Memo

Project: Melton East Precinct Structure Plan

Subject: 1967 Melton Highway, Grangefields Drainage Assessment

Figure 3: 2025 Draft PSP outcome

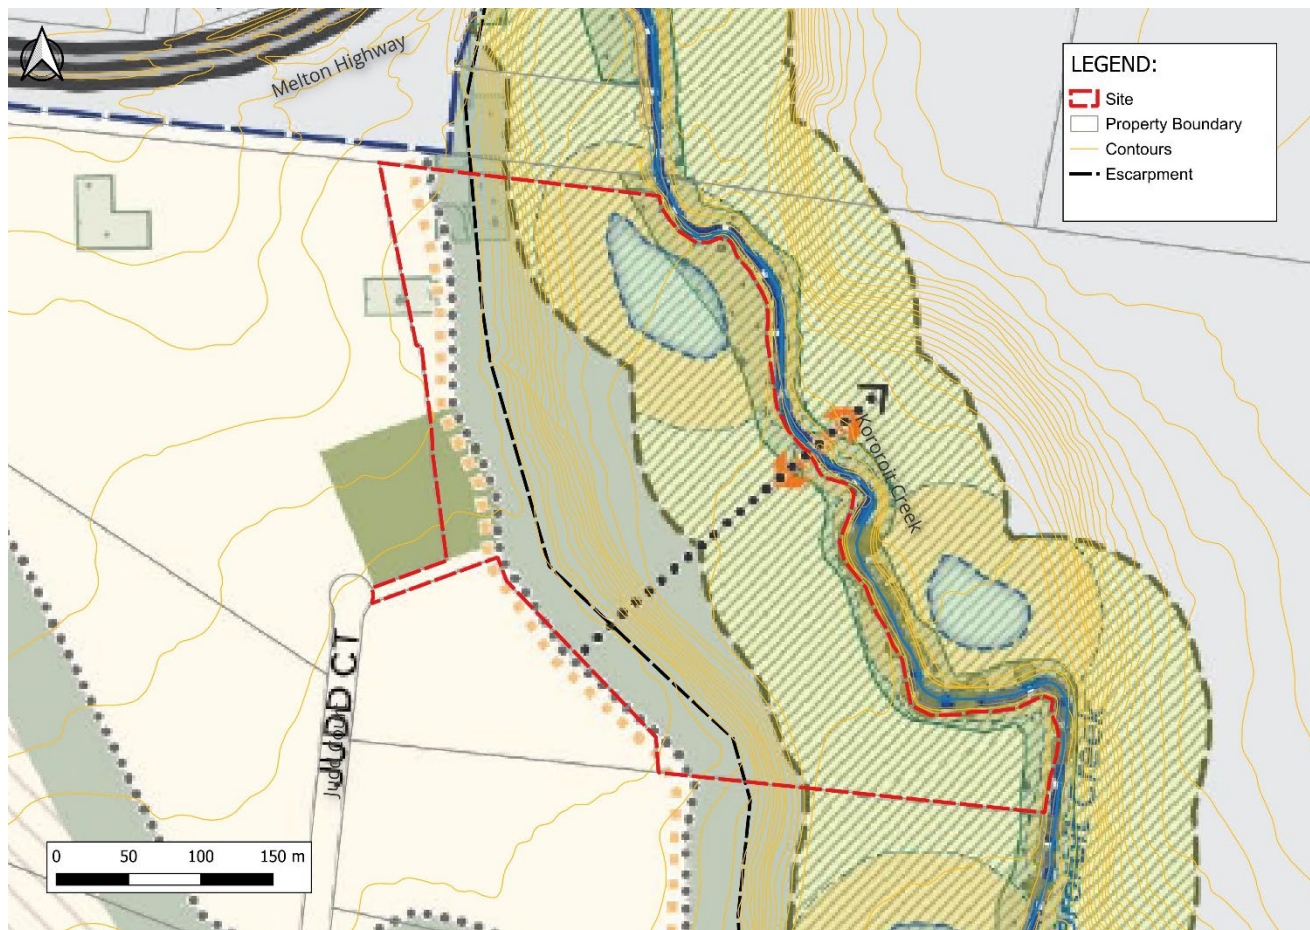
In the more recent iteration of the PSP documents, the Site has seen a dramatic reduction in the proposed residential development area being reduced to 0.680Ha (Split over three portions that are divided by a local park). A copy of the 2025 PSP within Parcel 13 can be seen in Figure 3. In this iteration of the PSP, the area is undevelopable in isolation and has resulted in a significant reduction in land value for the landholder.

Melbourne Water have recommended a 30m setback from the top of the escarpment which is excessive and appears inconsistent across the PSP in its application (refer parcels 46/48). This 30m buffer has absorbed almost all of the previously deemed developable area for parcel 13.

A 30m buffer should not be applied from the top of the escarpment within this PSP. In fact, the most appropriate boundary to the escarpment is the Local Access Street Residential – Conservation Area interface found on page 92 of the PSP document. A copy of which has been included Figure 4 below for ease.

Figure 4: Flood Extent

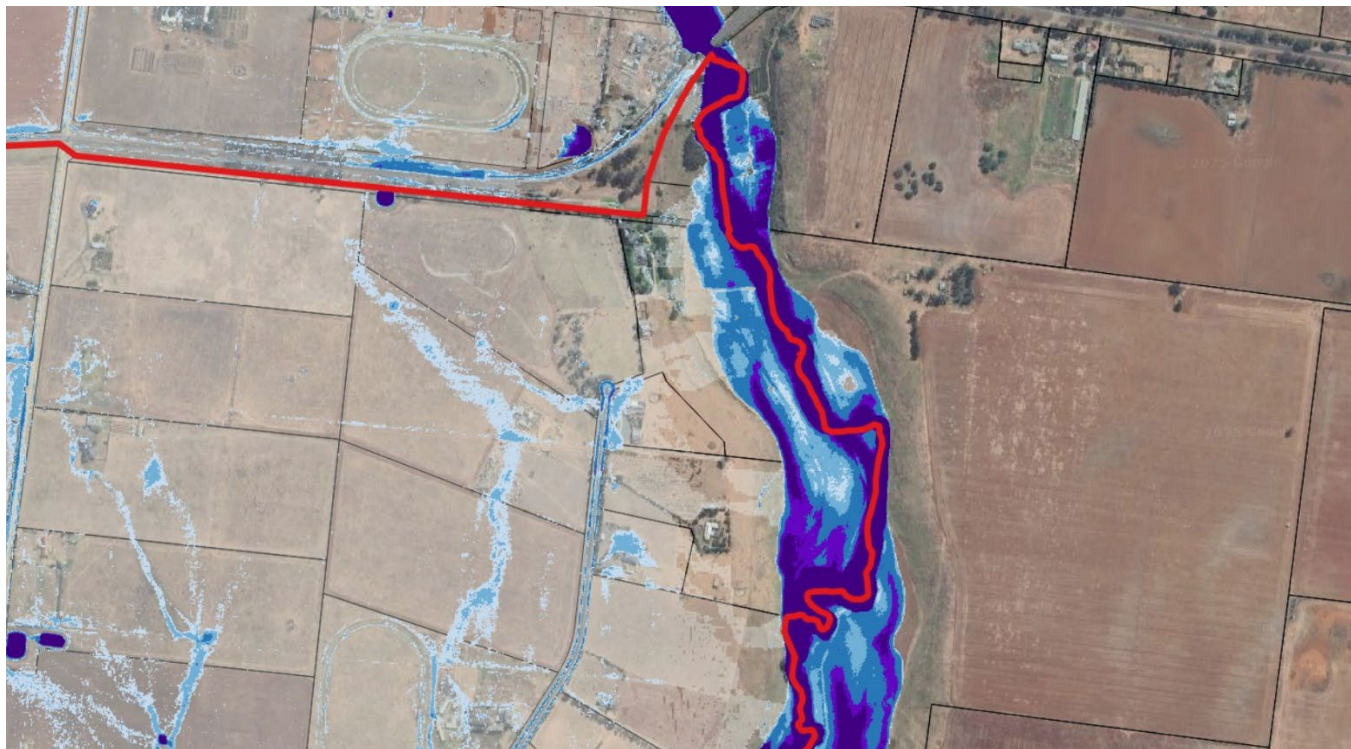
Whilst Melbourne Water does have the right to consider additional features for inclusion in their waterway corridor, their inclusions need to be practical and reasonable. There is no **hydraulic** reason to have a drainage and waterway area at the top of the escarpment. Besides minor local overland flows, there are no significant flows that will utilise this space. Flows within Kororoit Creek do not extend to the top of the escarpment (Note: we have requested the flood levels from Melbourne Water but have not received them in time to incorporate them into this Memo). The "Melton_East_PSP_-_Pre-development_Flood_Conditions_A3.pdf" shows that there is no overland flood flow or otherwise that extends up the escarpment and beyond the Kororoit creek lower flood plain in that area (refer to Figure 4).

Figure 5: Proposed Boundary to the escarpment

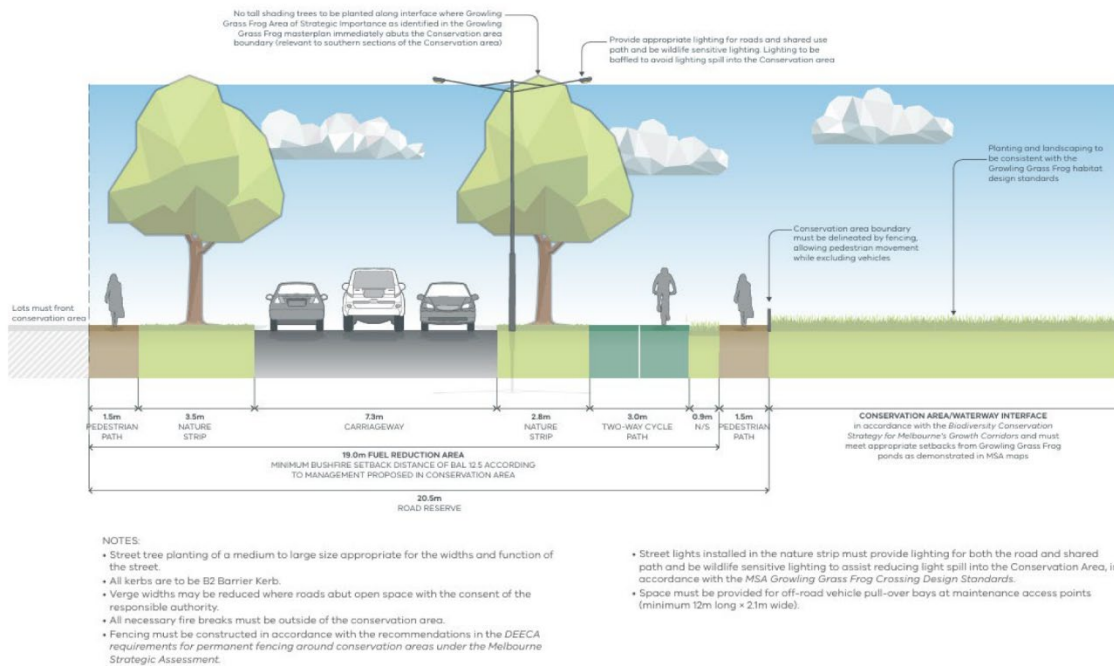
This road reserve, already incorporated into the PSP documentation, provides an appropriate buffer between residential housing and the potential bushfire fuel loads that can be generated within waterway corridors. Bushfire consideration now forms a key part of discussion at most PSP Panel hearings with regard to waterways (refer Croskell PSP, 2025).

Figure 6: Proposed PSP Development

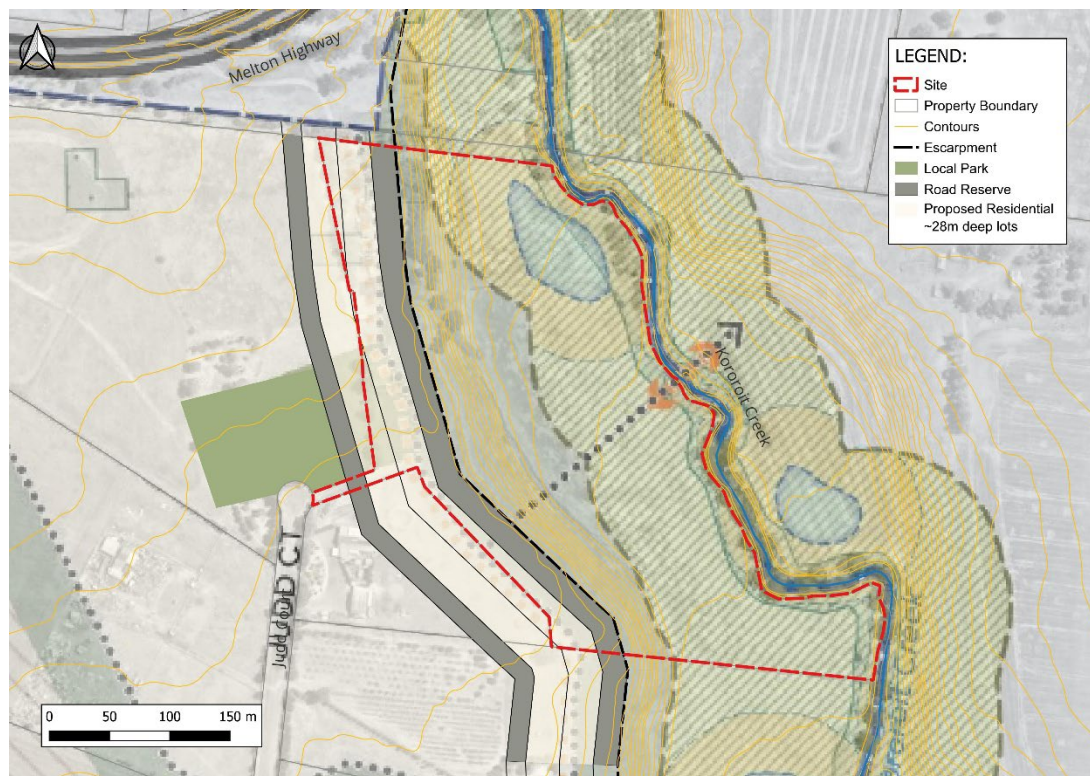
For this site, the proposed road reserve boundary will ensure the escarpment and corresponding view is enjoyed by path users, road users and residents to the west. For parcel 13, this also provides a suitable ~28m deep series of lots within the bulk of this specific parcel alongside the proposed road. This equates to approximately 2.4Ha of developable area for parcel 13 including the 20.5m wide road fronting the escarpment. A possible layout can be seen in Figure 5 below and shows that this site is developable independently.
